## RECALL INSPECTION AND REPAIR INSTRUCTIONS

**NHTSA Recall #:** 22V-068

**Models Involved:** 2018-2022 Allegro & Breeze units with the 2000W inverter option

**Purpose:** To correct the torque on the DCD panel and replace buss bar with 2/0 cable and update torque label.

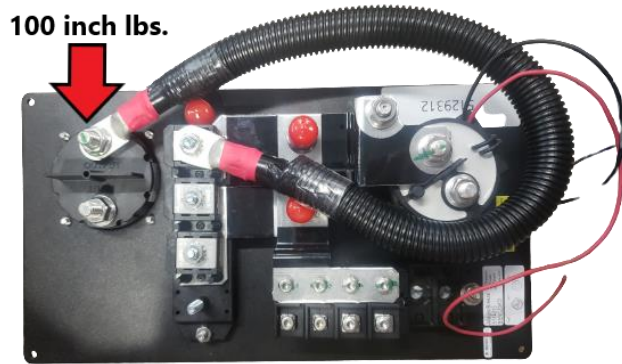
- Remove the DCD panel, and locate the buss bar between the inverter stud and the 400A Zcase fuse.

- Using the wrench, remove the nuts from the studs, and remove the buss bar.

- Using the cable provided, connect one end of the cable to the stud for the inverter switch. This will require using the torque wrench set on 100 in lbs.

- Loop the harness around behind the board, and connect the other end of the cable to the stud for the 400A Zcase fuse. This will require using the torque wrench set on 100 in lbs.

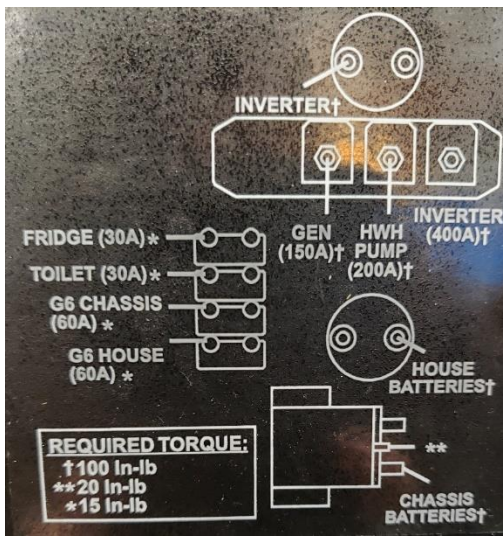
- Install the 5129401 CVR STUD RBBR RED on the studs. This will provide protection for the added cable
